Certificate of Appropriateness

Property	2000 W. Wisconsin Ave.	Pabst Mansion
Description of work	Conduct emergency repairs to the exterior of the building in order to address water infiltration issues. Restoration to brick and terracotta at the dormers, gables, window hoods, etc. throughout the south, west, and north elevations. Specific regions and scope of work are attached. Masonry in these areas will be repointed and cracks in the masonry will be repaired and sealed to be made weathertight.	
Date issued	11/6/2019	PTS ID 114805 COA masonry repairs

South Elevation – West Gable

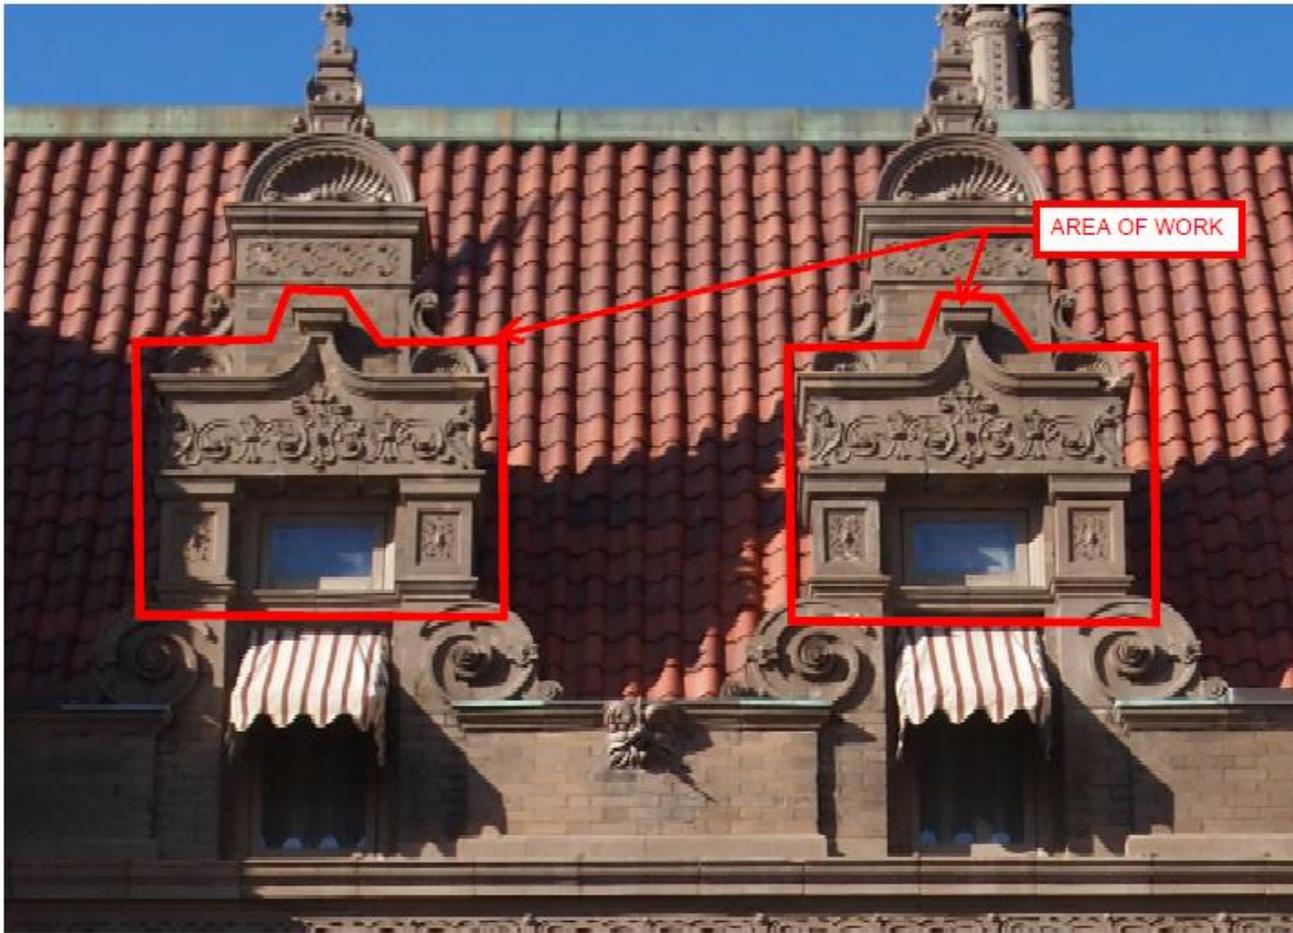
Repoint terra cotta and brick at all exposed faces within indicated zone

Replace damaged and failing sealant at brick mold around transom windows at head of windows below

South Elevation – Central bay dormers

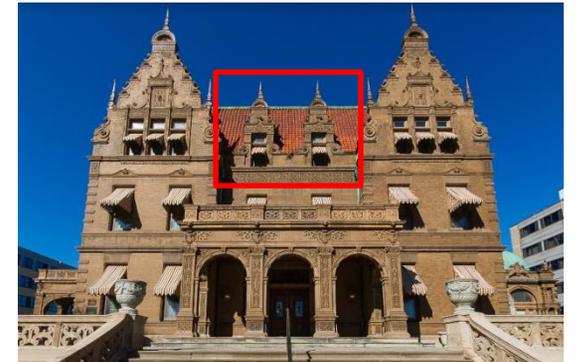
Repoint terra cotta and brick at all exposed faces within indicated zone

Repoint open head joint at horizontal mullion, provide elastomeric polyurethane with release tape backer to seal the joint.

Replace all damaged and failing sealant at brick mold around transom windows and at head of window below

South Elevation – East Gable

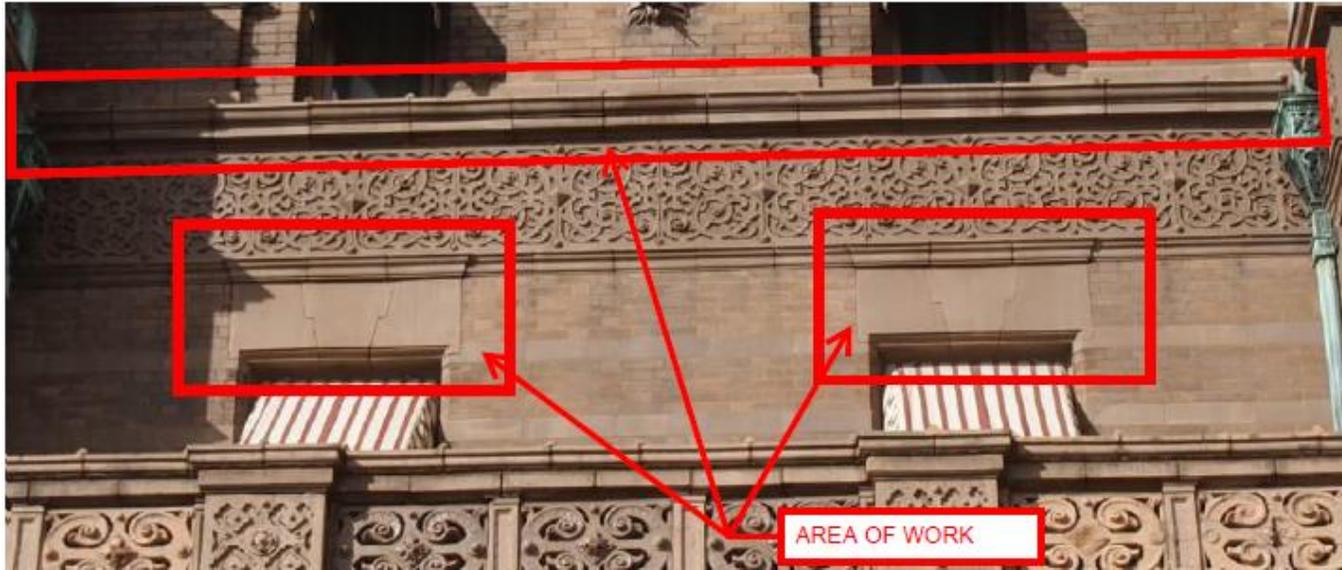
Repoint terra cotta and brick at all exposed faces within indicated zone

Replace damaged and failing sealant at brick mold around transom windows at head of windows below

South Elevation – Second Floor
Center bay windows

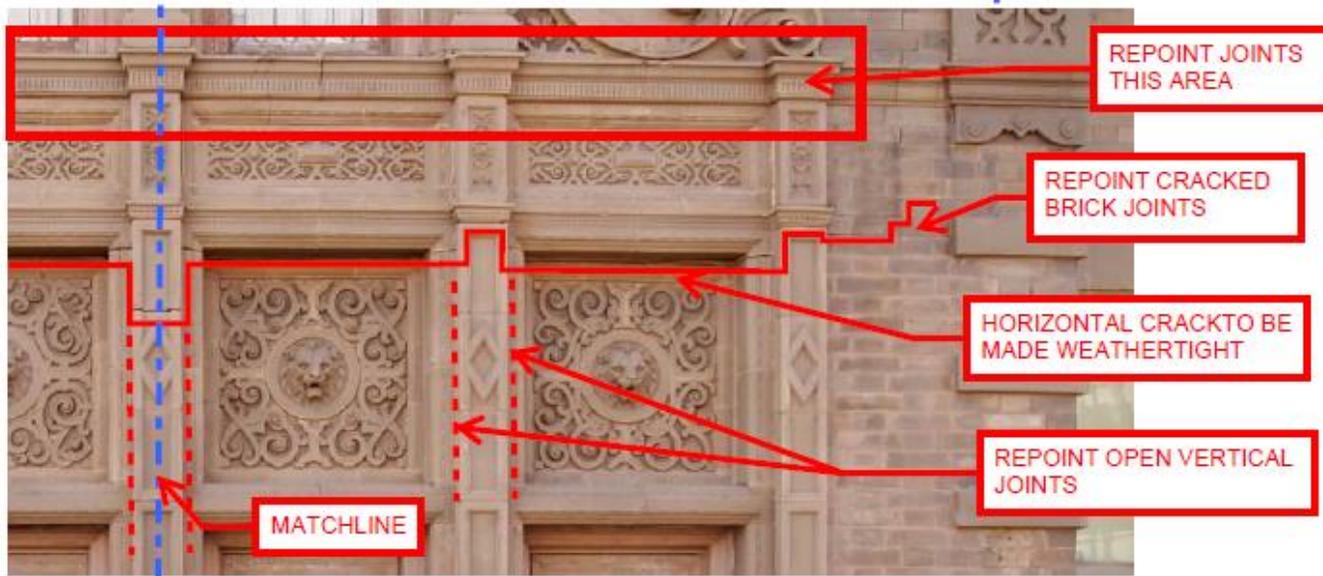
Repoint terra cotta and brick at all exposed faces within indicated zone and provide polyurethane with release tape backer to finish off repointed skyward joints of belt course

Replace damaged and failing sealant at brick mold around single hung window heads and upper jambs

North Elevation –Airing Porches, Second & Third floor

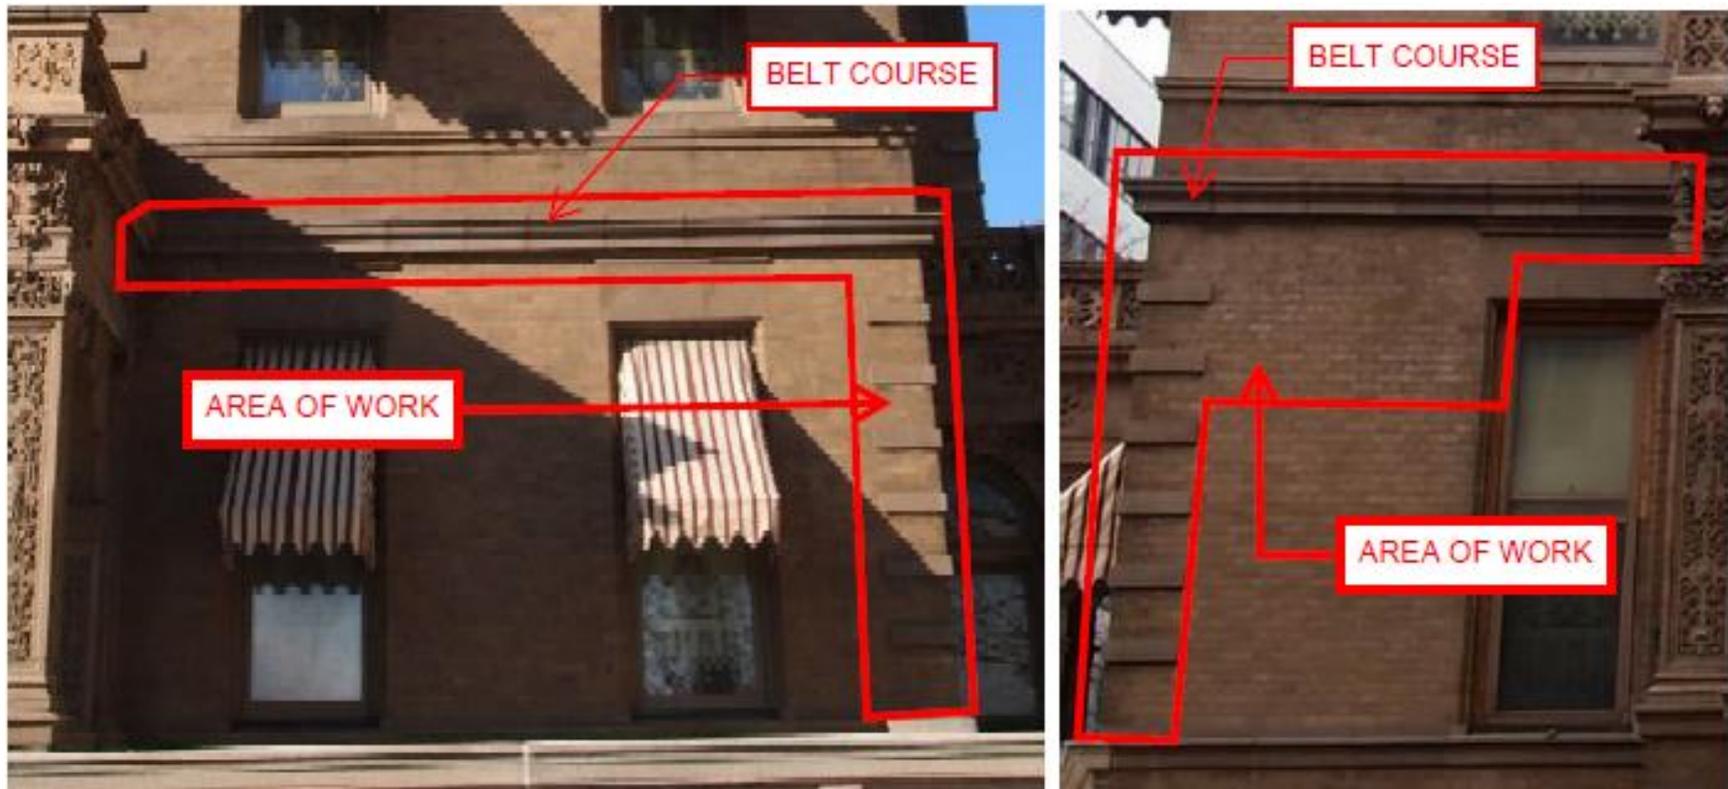
Repoint all terra cotta and brick joints, provide elastomeric polyurethane with release tape backer at skyward joints

Inspect cracked brick between porch lintel and 3rd floor window sill belt course, determine appropriate action – either replaced cracked brick (from owner's supply) or repair cracks with mortar or closed cell backer rod and elastomeric polyurethane sealant with color selected from manufacturer's standard colors.

At east (left) end of 3 piece terra cotta lintel, inspect cracked terra cotta unit and determine appropriate crack repair for unit and proceed with action following owner review.
